## **APPLICATION TO DISCHARGE PRE-COMMENCEMENT CONDITIONS FOR REDEVELOPMENT AND CHANGE OF USE OF FORMER MILL SITE TO FORM 19 RESIDENTIAL UNITS**

**HINCHLIFFE MILL, WATER STREET, HOLMBRIDGE, HOLMFIRTH, HD9 2NX**

**LPA REF: 2026/90162**

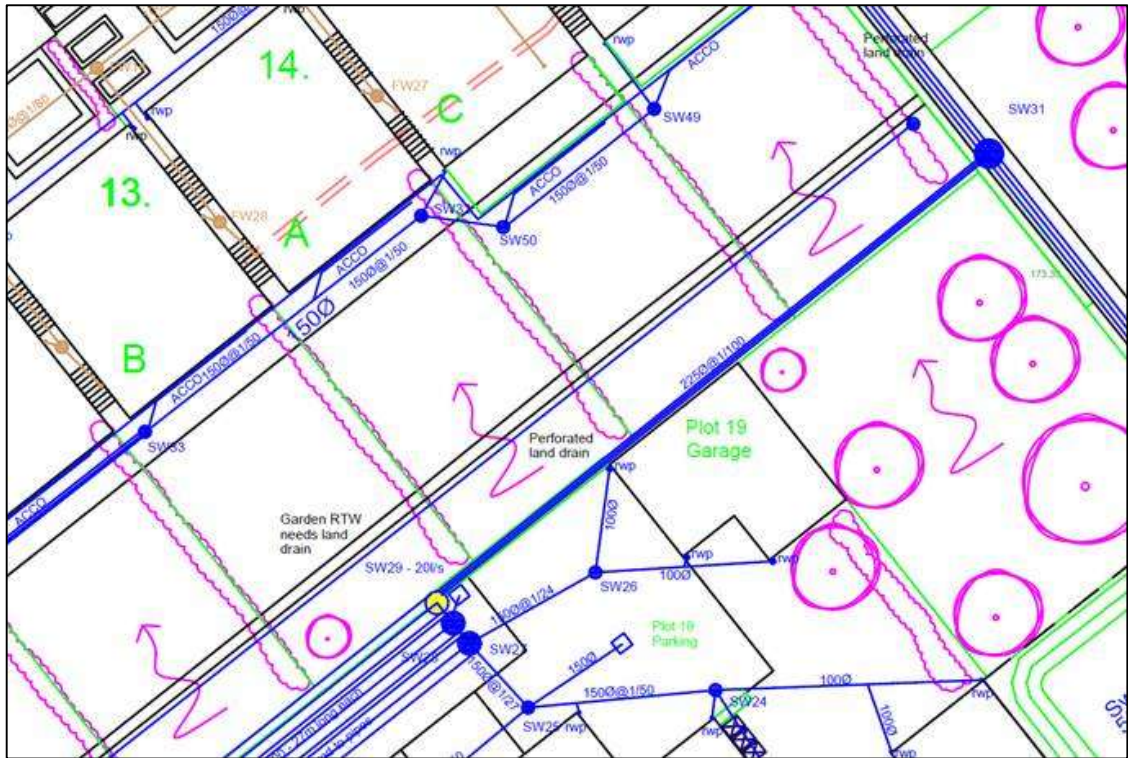
- 1) "The revised report (2025-3388, Drainage Conditions, Rev D) has been updated, however it is unclear where the flow control devices for each of the areas (Areas 1, 2 and 3) are located as the MH reference numbers given in the Notes are not indicated on the drawing. The drainage drawing (EWE/3388/01 Rev D, dated 11/02/26) indicates headwall HW1 draining to the existing Mill Pond and headwall HW4 draining to the river but there is no other apparent headwall location to account for the 3rd discharge point."

- 2) "The developer should clearly indicate on drawing EWE/3388/01 the location of each of the flow control devices together with its associated discharge rate, design head, outlet diameter, and Invert Level to allow the LLFA to cross-check the inputs in the Hydraulic Calculations in Appendix C, D and E."

- 3) “The total lengths of the 900mm dia pipes should be indicated on the drawing to allow the LLFA to cross-check the inputs in the Hydraulic Calculations in Appendix C, D and E.”

**Applicant's Response:** Drainage Layout Plan EWE/3388/01 Rev F now shows manhole reference numbers. SW29 being the third flow discharge point, collecting water from Area 3 (0.147 ha) then connecting on to manhole SW31 to discharge down the 450mm diameter pipe to headwall HW4 into the River Holme. Therefore a third headwall is not required (see drawing extract below).

**Applicant's Response:** Drainage Layout Plan EWE/3388/01 Rev F now details this information for each flow control manhole (in yellow) and in the 'Notes' section.

**Applicant’s Response:** Drainage Layout Plan EWE/3388/01 Rev F now states the lengths of the 900mm attenuation pipes to all 3 areas. These are:

Area 1 – one length at 34.7m long which corresponds with Drainage Conditions Report Appendix C (Page 20)

Area 2 – three lengths at 60m long. It should be noted Appendix D of the Drainage Conditions report (page 24) states the length required to be 90m as a double pipe arrangement. The software utilised will only model a double pipe scenario, therefore the engineer has taken the 180m length required, then divided by three to fit into the space available on site.

Area 3 – two lengths at 27m long. This corresponds with Appendix E of the Drainage Conditions report (page 28) which models a double pipe structure as shown on plan.
